EPA REVIEW OF SHELL BENZENE MONITORING

Publication 1019.1*

March 2006

Assessment of the EPA Review of Shell benzene monitoring for March and April 2005

Figure 1: Hourly benzene readings from Shell's benzene monitoring system at the north-west site versus wind direction for results in April 2005

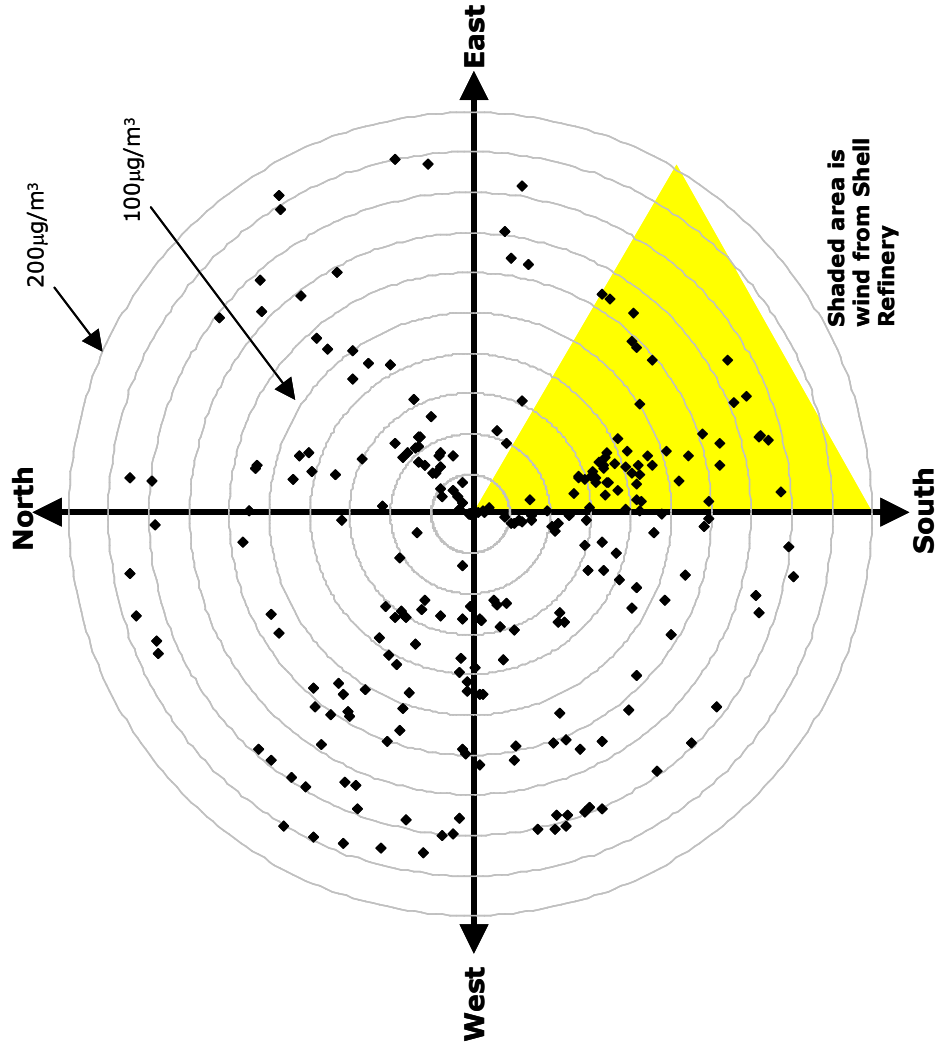
Benzene levels would be more likely to rise when the wind is blowing from either Shell Refinery or the Princes Highway. Benzene levels versus wind direction are shown in Figure 1.

During the 297 hours that Shell’s benzene monitoring system gathered data in March/April, winds blew in a southerly direction (from the direction of the refinery) for 33 hours. However for approximately 264 hours Shell’s benzene monitoring system logged apparent high levels of

benzene, when the wind was coming from a wide range of directions.

Figure 2: Hourly benzene readings from EPA's monitoring system at the north-east site versus wind direction for results in April 2005

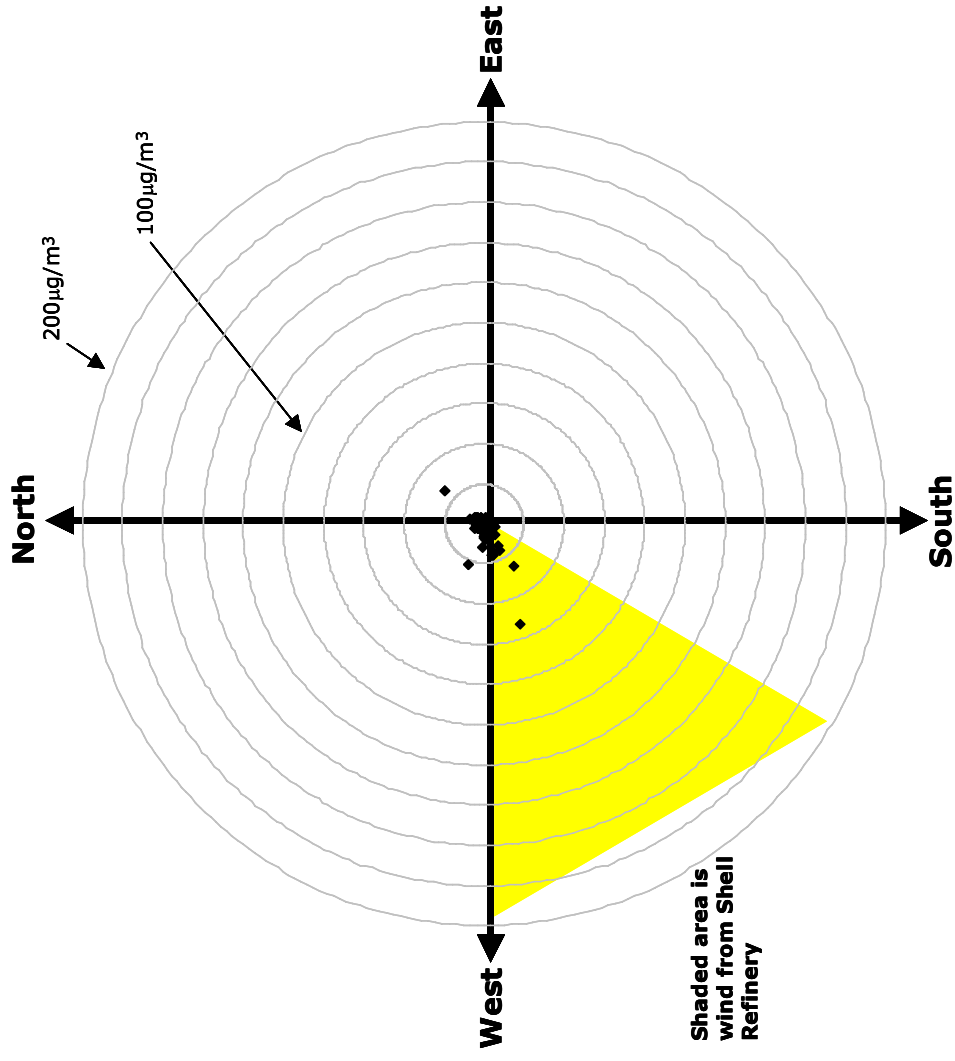
EPA’s monitoring system located at the north-east site, a similar distance from the refinery, did not detect these high levels of benzene during the same period (Figure 2).

Figure 3: Comparison of Shell's and EPA's hourly benzene levels at the north-east site, September 2005

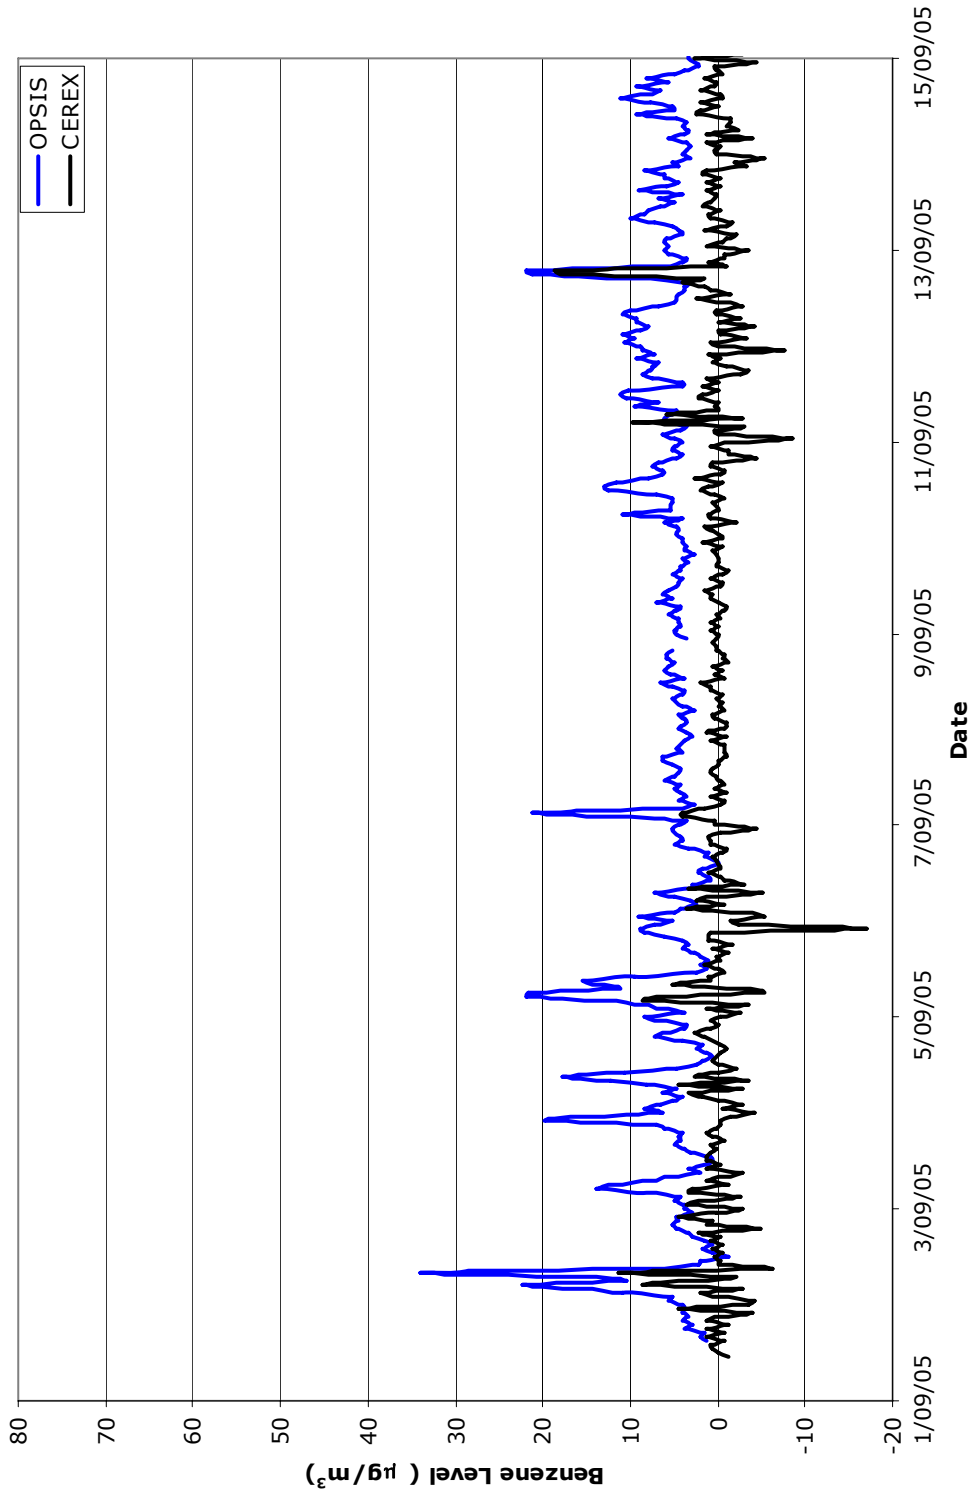
Hourly benzene levels measured by Shell and EPA are compared in Figure 3. It can be clearly seen that there is little correlation (note that the uncertainty of EPA data is ±5 µg/m³). Statistical analysis of the data also indicated that there was poor correlation. This was due in part to fluctuating and negative five-minute results generated by Shell.

Figure 1 Absorbance spectrum calculated for 20 March 2005.

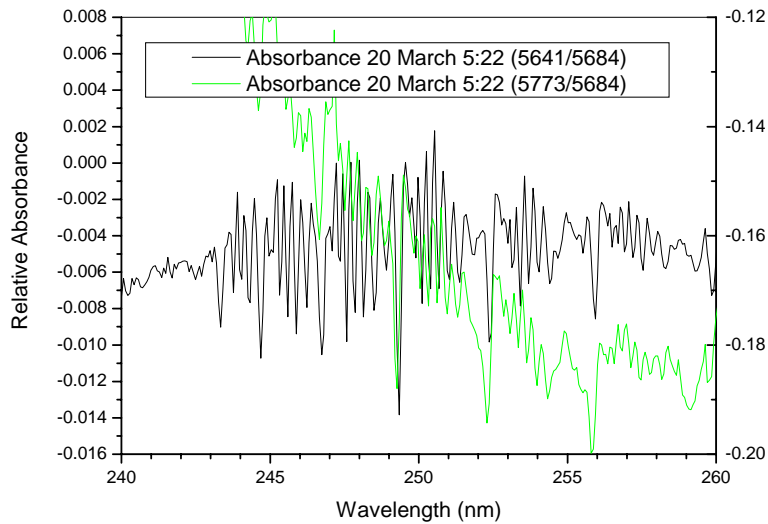
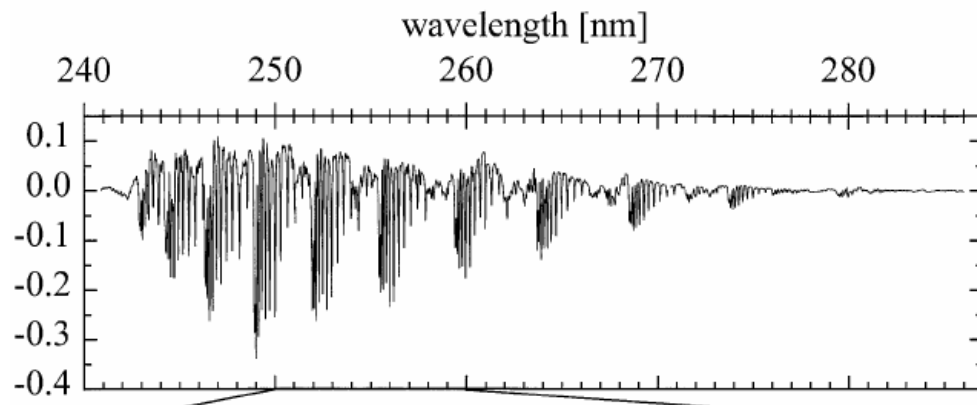
For the period on 20 March where data was rejected, absorbance spectra have been calculated and are shown in Figure 1.

Absorbance spectra have been determined using a background taken before and after the period of calculated high benzene. As can be seen, there are a lot of spectral features observable, and they are assignable to absorption due to oxygen (See Figure

2). This will lead to a low correlation coefficient and invalid analysis. These analysis results should be excluded.

Figure 3 Absorbance spectrum calculated for 3 April 2005 18:47

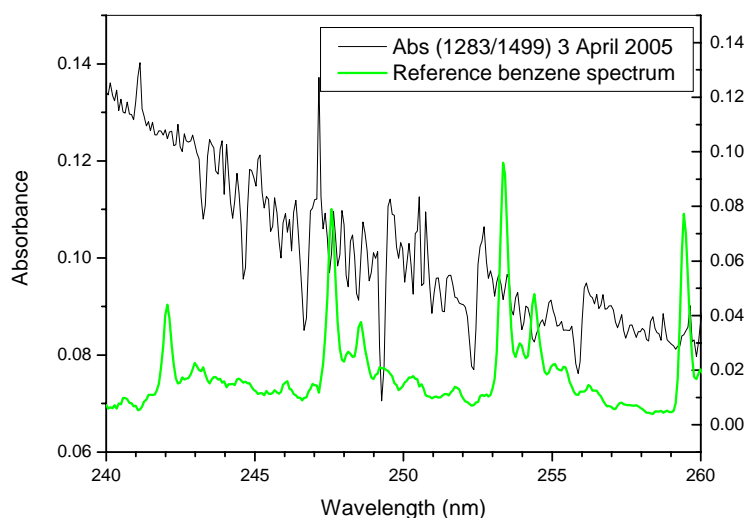
This data was discounted due to poor background selection and low correlation. An example spectrum is shown below (Figure 3), with a reference spectrum of benzene shown for comparison.

While there are clear features in the spectrum due to O_2 and possibly some other species, there is no structure that could be clearly assigned to benzene. Further, as the time between the reference and measurement increases there is an apparent increase in spectral “noise”, and hence the likelihood of false benzene estimates increases. During this period a single reference from 3 April was used. Once again the analyses from this period should be disregarded.

Figure 4 The benzene spectrum recorded during the system audit in March and the supplied reference spectrum for benzene (in green).

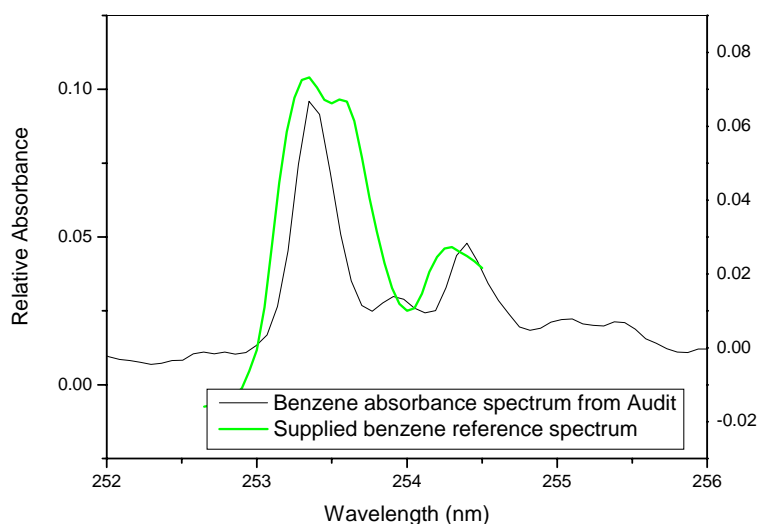
reference benzene spectrum. Shown below (Figure 4) is the comparison spectrum shown in Figure A4 (and supplied to me as a benzene reference spectrum) and the spectra retrieved from the calibration (using the 8 March calibration run). The supplied benzene spectrum is clearly not correct, either in wavelength scale or lineshape. This makes a manual comparison more difficult. Despite this, the conclusion of this section of the review is correct.

Figure 7 Fitting of a DOAS spectrum following filtering by Volkamer et al (1998).

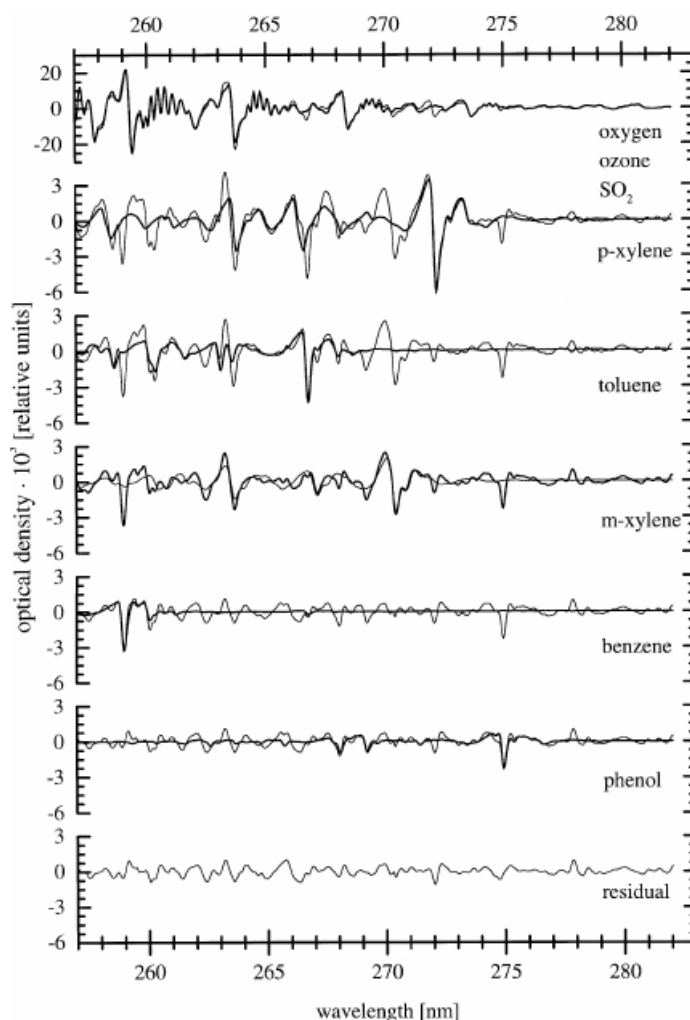
There appears to be no attempt made to allow for the oxygen absorption features within the analysis spectral window. This fundamentally limits the accuracy of benzene retrievals. It appears to be the main reason for reduced r^2 retrievals through much of the disputed periods. (For all the spectra shown in figure A5 the structure shown is dominated by oxygen). Note that these oxygen features will change as the amount of oxygen present varies (i.e. with pressure). This will determine the lower limit of benzene concentrations that are retrievable, and this lower limit will depend on atmospheric conditions. For a more reliable retrieval the structure due to oxygen

needs to be explicitly fitted. This is discussed in some detail by Volkamer *et al.* [1998]. Some of the techniques discussed there, such as a high frequency filter to remove the dimer spectral features, may indeed be used by the software, although I can see no evidence of this.

Shown below is an example of this fitting procedure as reported by Volkamer [1998]. The top panel shows the full (filtered) spectrum and the fit for oxygen. The following panels then show the resultant residual and the fit for the components listed.

3. Alternative spectral analysis strategies should be investigated that explicitly calculate the impact of oxygen on the observed spectra.
